Product Change Notification

Document No PCN-A-1050413 Revision 1.0

The power icon image on OSD membrane button of Rack Mount Display has been changed.

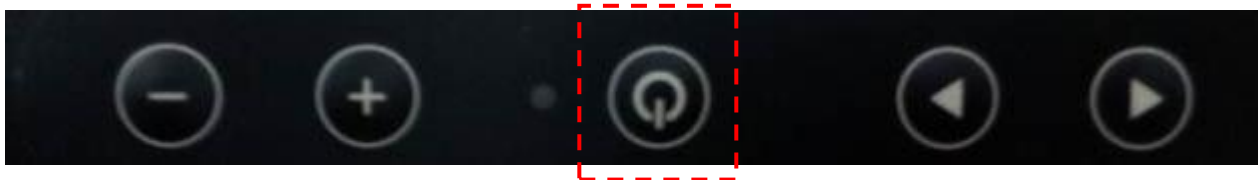
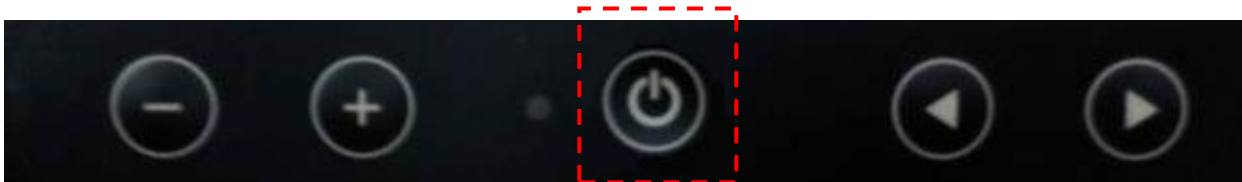
Due to the power icon of OSD membrane is different from standard, Winmate has revised the icon. This new icon will not affect any mechanical housing or electronic change. The comparison picture as below;
